Z-104
(2015)

SANDTOWN ROAD TRACT
FOR TYLER CHANDLER HOMES

PETITION NO.: Z-104

ZONING COMMENTS:

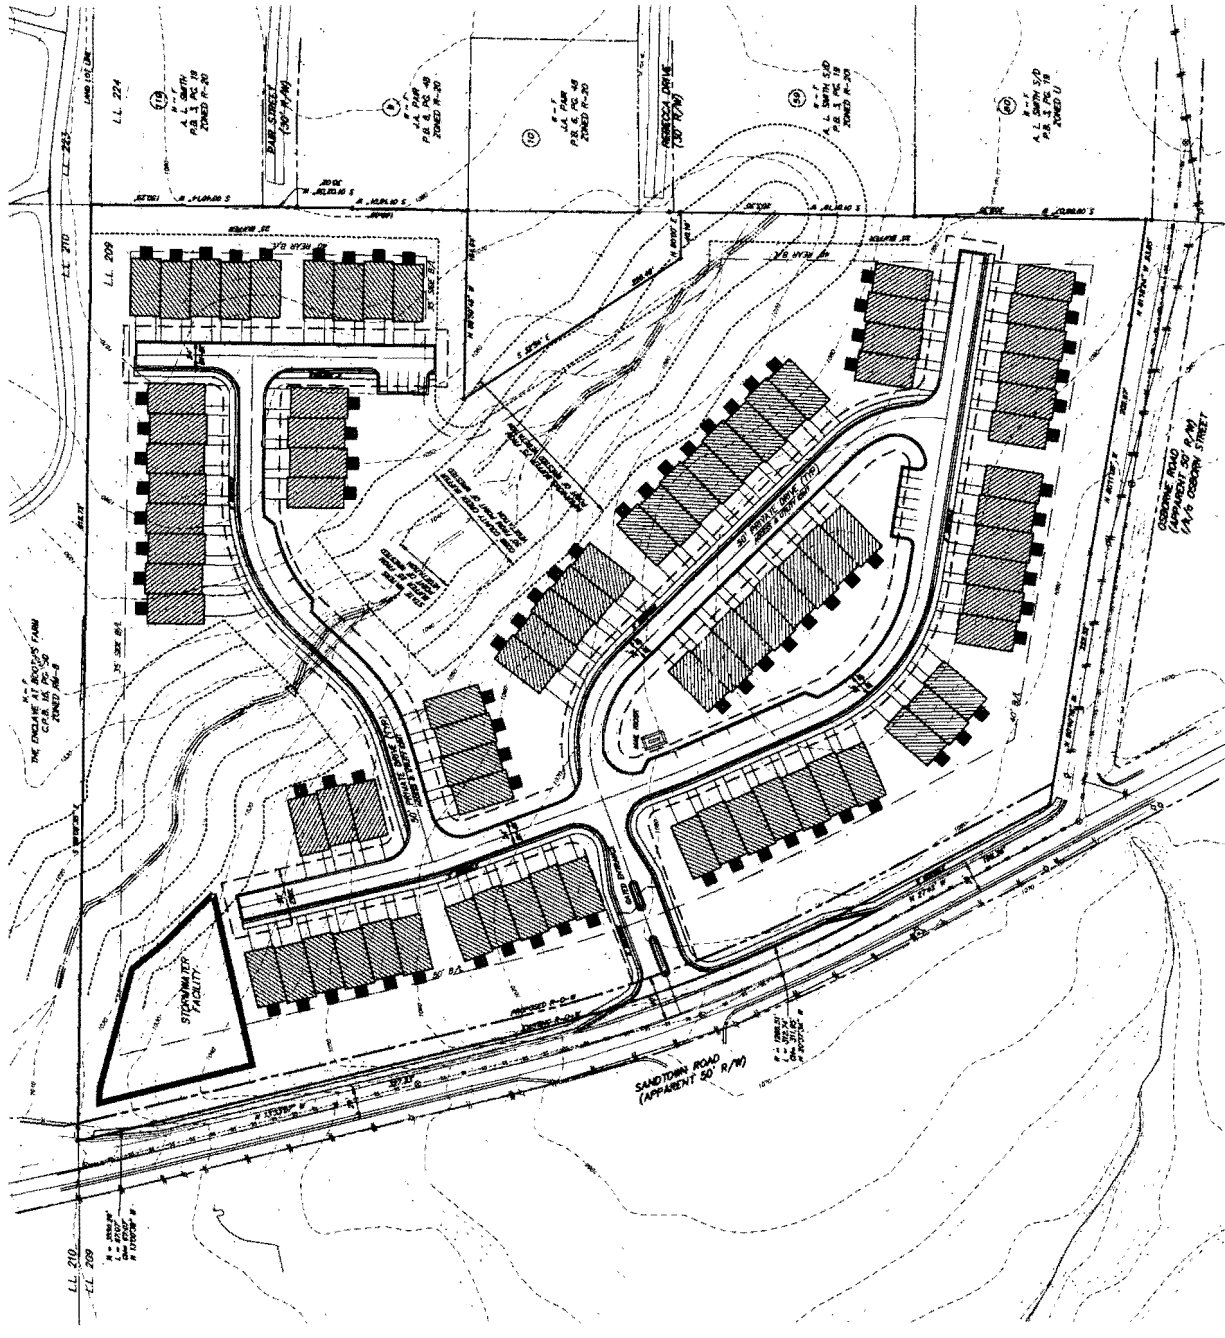
INSUFFICIENT INFORMATION

- No Stormwater controls shown _____
- Copy of survey is not current – Additional comments may be forthcoming when current site conditions are exposed.
- No site improvements showing on exhibit.

Sandtown Road is classified as a major collector and according to the available information the existing right-of-way does not meet the minimum requirements for this classification.

Recommend applicant consider entering into a development agreement pursuant of O.C.G.A. 36-71-13 for dedication of the following system improvements to mitigate traffic concerns: a) donation of right-of-way on the east side of Sandtown Road, a minimum of 40' from the roadway centerline.

Recommend curb, gutter, and sidewalk along the Sandtown Road and Osborne Road frontages.

Recommend no access to Osborne Road.
